PENRITH CITY COUNCIL

MAJOR ASSESSMENT REPORT

Application number:	DA18/0890.01
Proposed development:	Review of Determination - Proposed Construction of a Five (5) Storey Residential Flat Building with Basement Car Parking
Property address:	36 Rodley Avenue, PENRITH NSW 2750 38 Rodley Avenue, PENRITH NSW 2750
Property description:	Lot 58 DP 33490 Lot 59 DP 33490
Date received:	26 August 2019
Assessing officer	Ian Dencker
Zoning:	Zone R4 High Density Residential - LEP 2010
Class of building:	Class 2 , Class 7a
Recommendations:	Refuse

PRE-ADAPTABLE UNIT 01

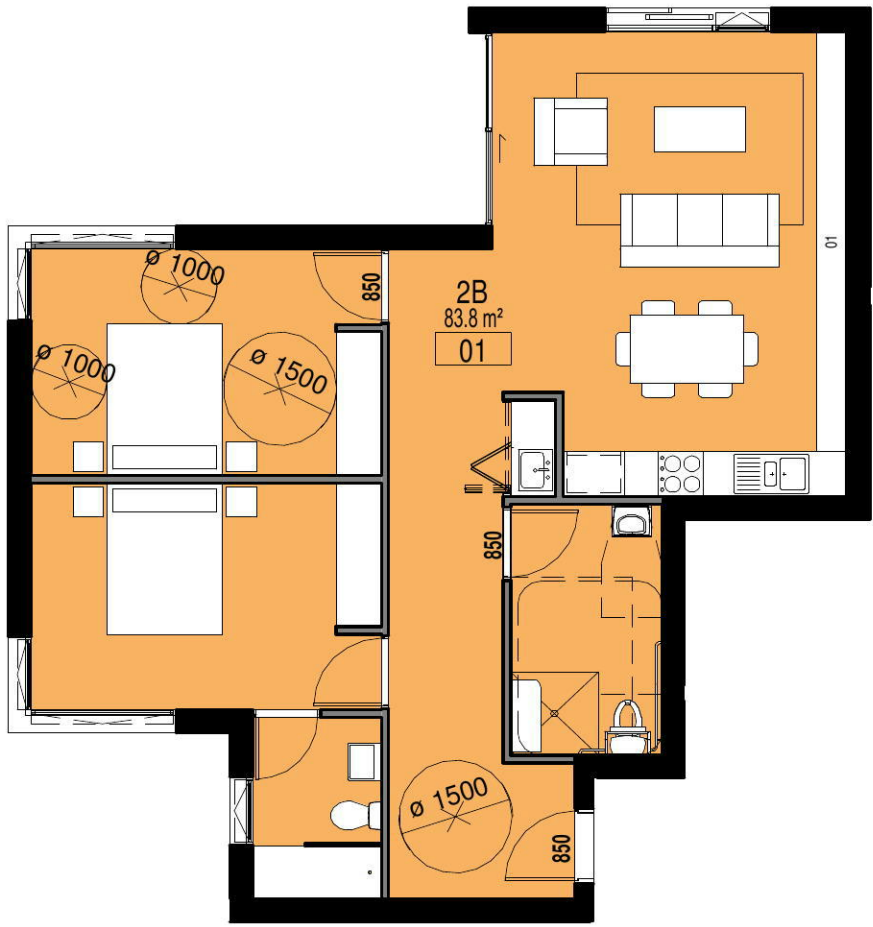
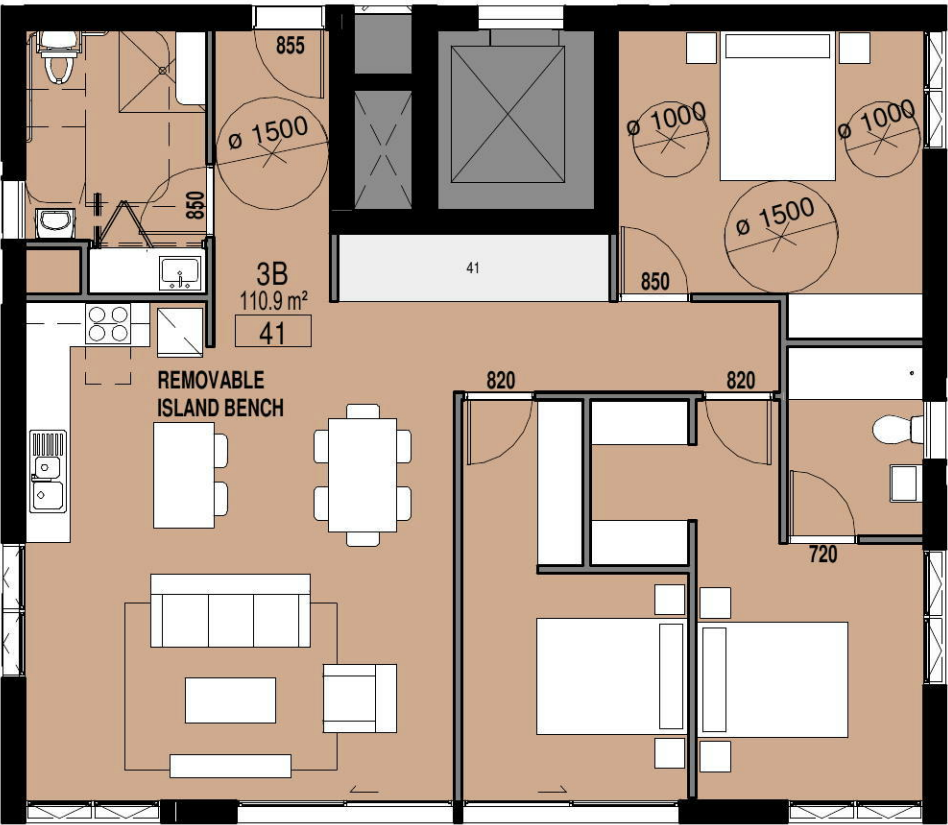
4Q-2	Adaptable housing is to be provided in accordance with the relevant Council Policy.	A total of 2 adaptable units are proposed – Units 01 and 41.	Yes.
4U-1	Adequate natural light is provided to habitable rooms.	Except for Unit 03, apartment depths and open floor plan arrangements allow light into most kitchens, dining and living areas. However, as detailed previously, inadequate solar analysis has been provided to demonstrate availability of natural light.	No.
4V-2	Water sensitive urban design systems to be designed by suitably qualified professional.	The development application was referred to Council's internal Environmental Waterways Unit. The WSUD plans generally comply with Council's policy. Should development consent be granted, the WSUD proposal could be supported provided amended plans were submitted prior to issue of a Construction Certificate, along with other conditions.	No - but subject to amended plans being submitted proposal could be supported subject to conditions

Figure 2 Height limit breaches

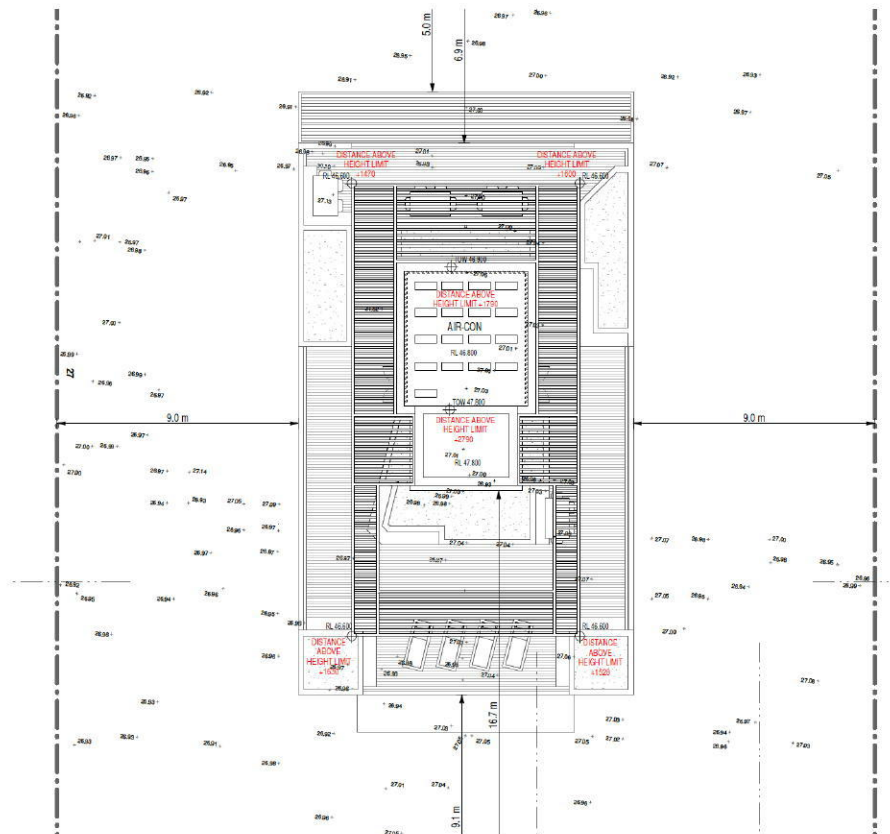
The end result is that the lift overrun rises above the 18m height limit by 2.79m (15.5%). The north-western corner exceeds the height limit by 1.47m (8.2%), the north-eastern corner by 1.6m (8.8%), the south-western corner by 1.63m (9%) and the south-eastern corner by 1.52m (8.4%).
